# West Don Lands Block 20

Detailed Design

Review Stage: Detailed Design

# Recap from April 2021 Stage Two WDRP Consensus Comments

# **Previous Materiality**

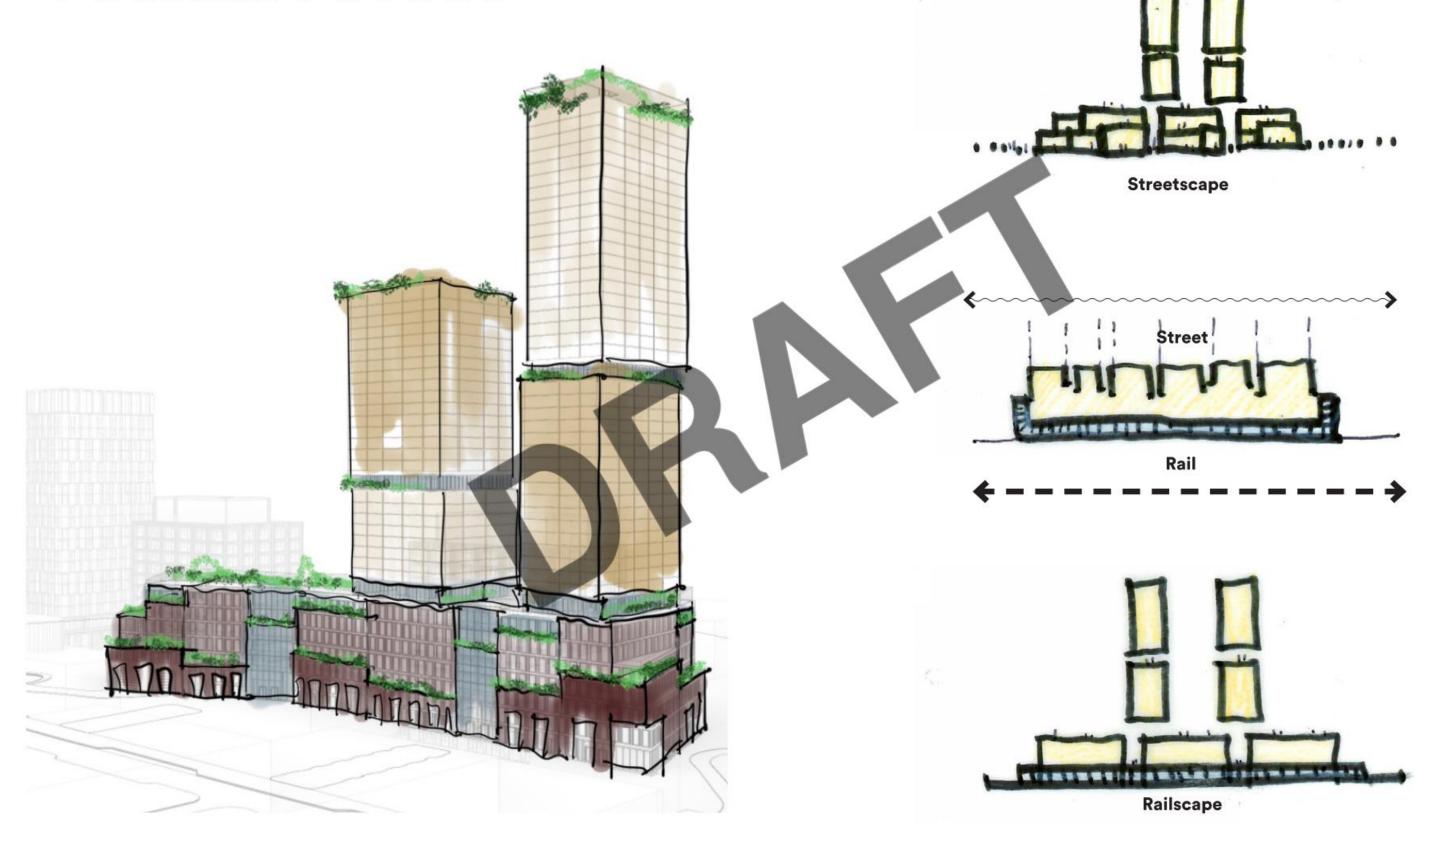
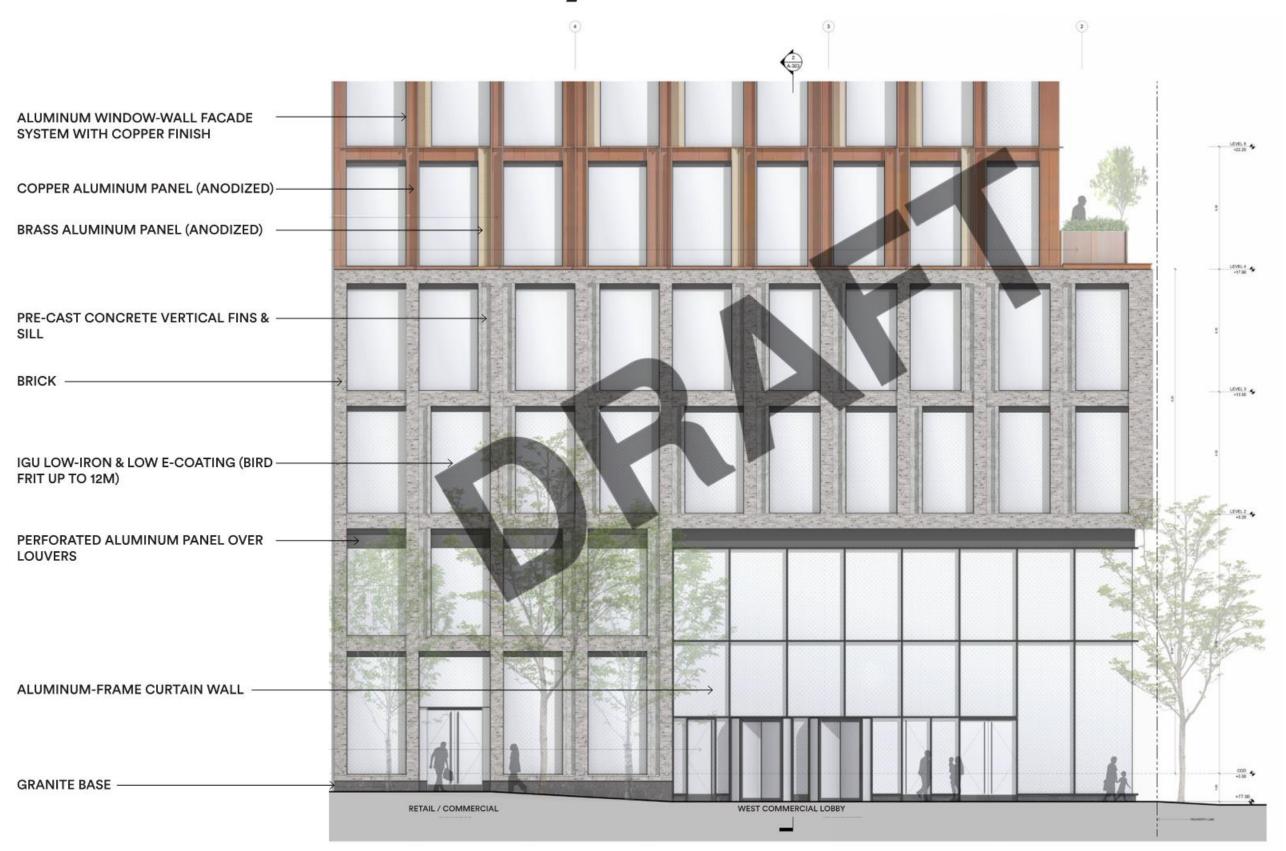
- Building facade materiality requires further explorations, consider bringing more Distillery District "Red" to the base of the building, i.e. extending the palette from the towers to grade to support the character of the neighbourhood while creating a unique identity for the project.

### **Podium Glass**

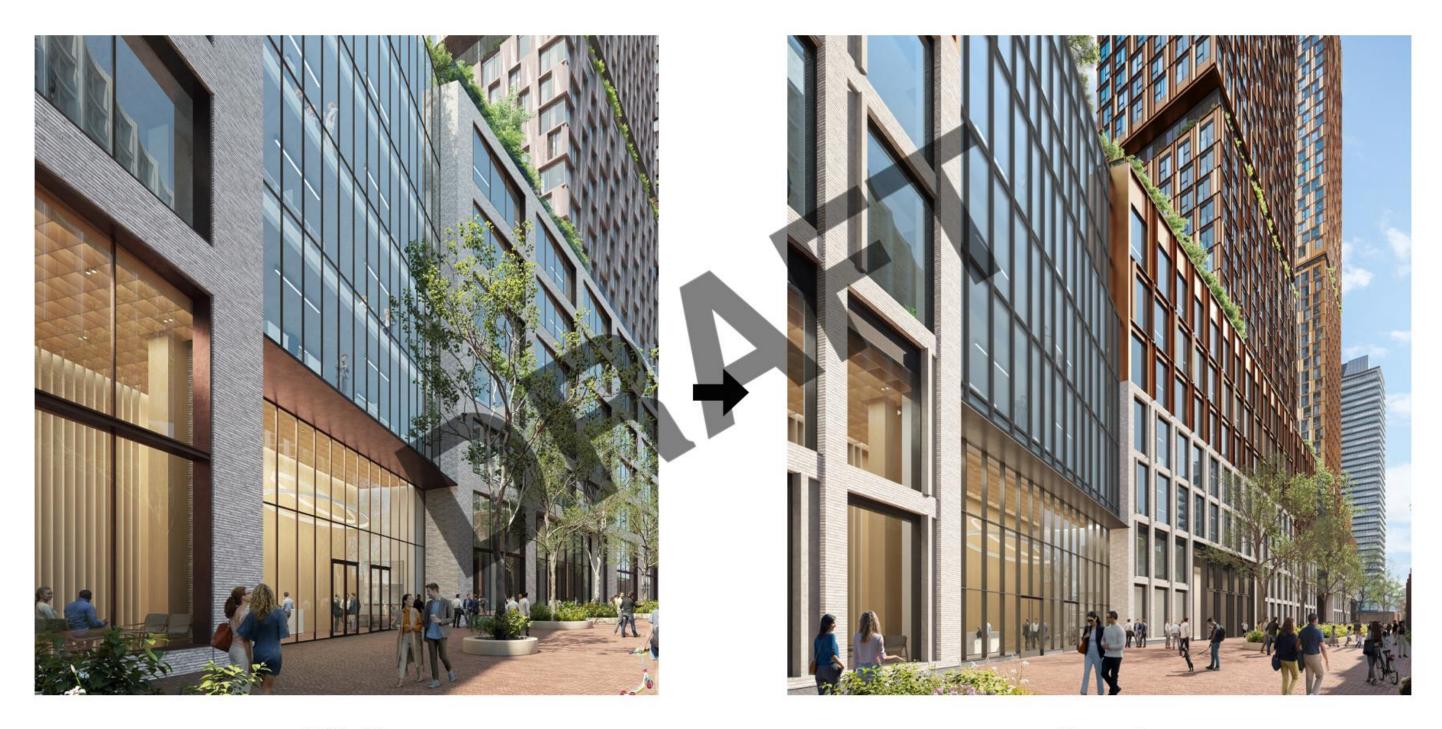
- The large, glazed atrium spaces on the ground floor do not feel appropriate to the Distillery District, consider finer-grain facade alternatives to provide transparency and openness that are in keeping with the characteristics of the neighbourhood.

### **Crash Wall Finish**

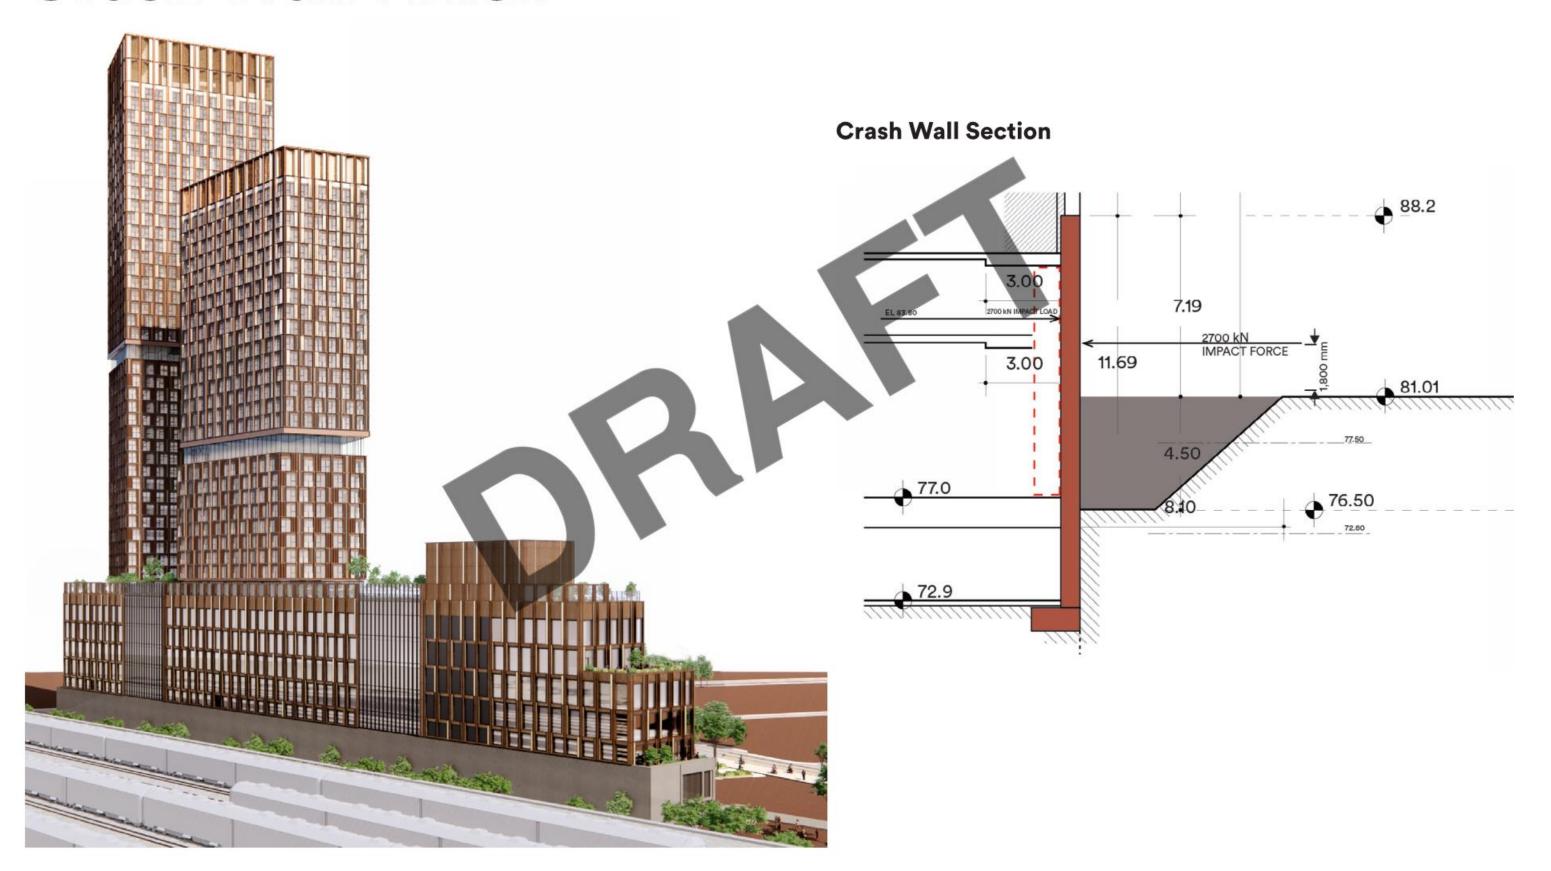
- As an important visual gateway into the city from the east, provide design opportunities for the crash wall, consider the design, facade materiality, public art opportunities.

#### **Pedestrian Level Wind**

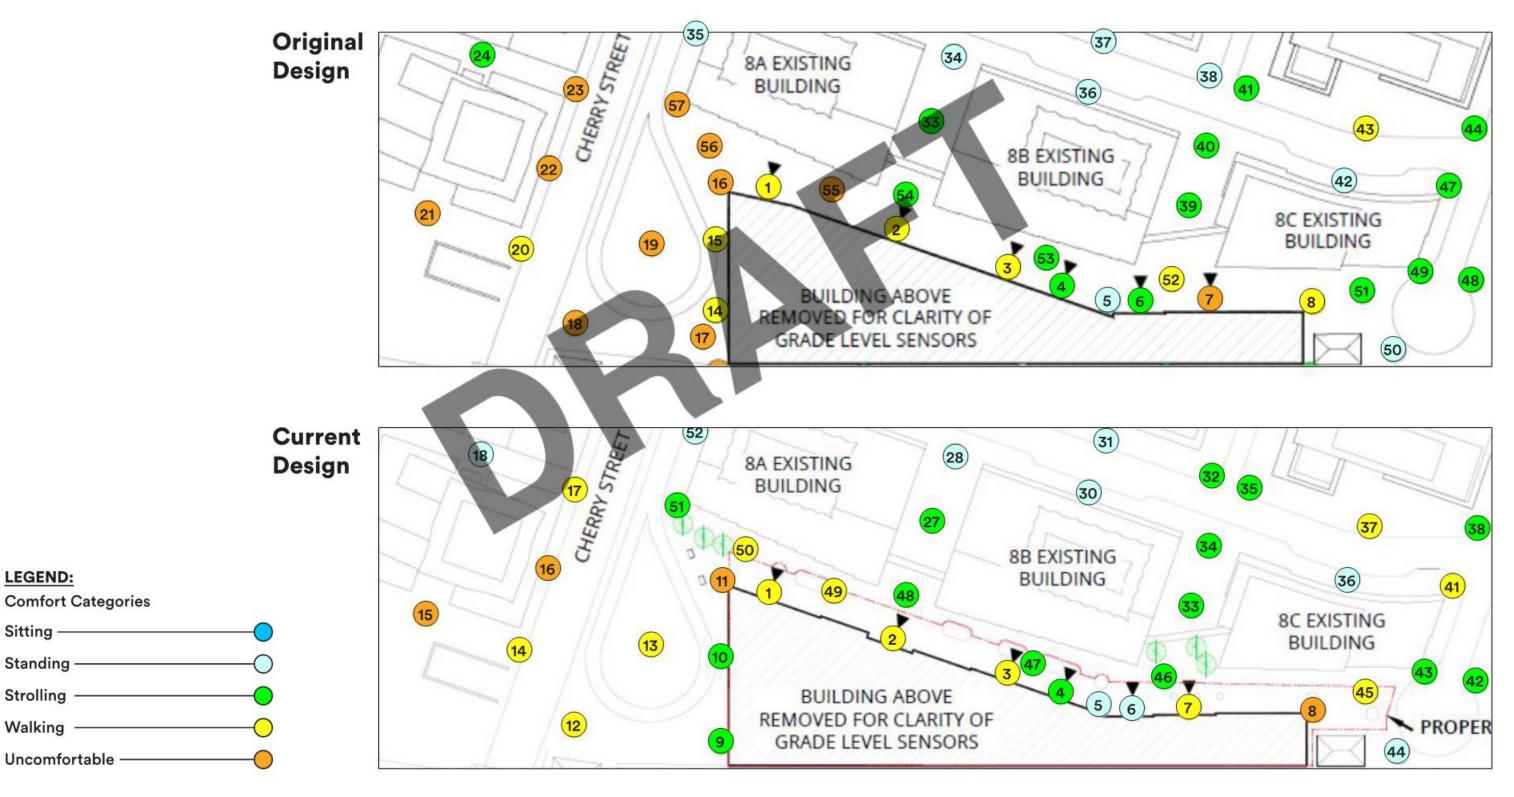
- Wind impact are concerns for terraces and rooftop amenity areas, conduct studies, and provide further mitigation strategies to ensure comfort.
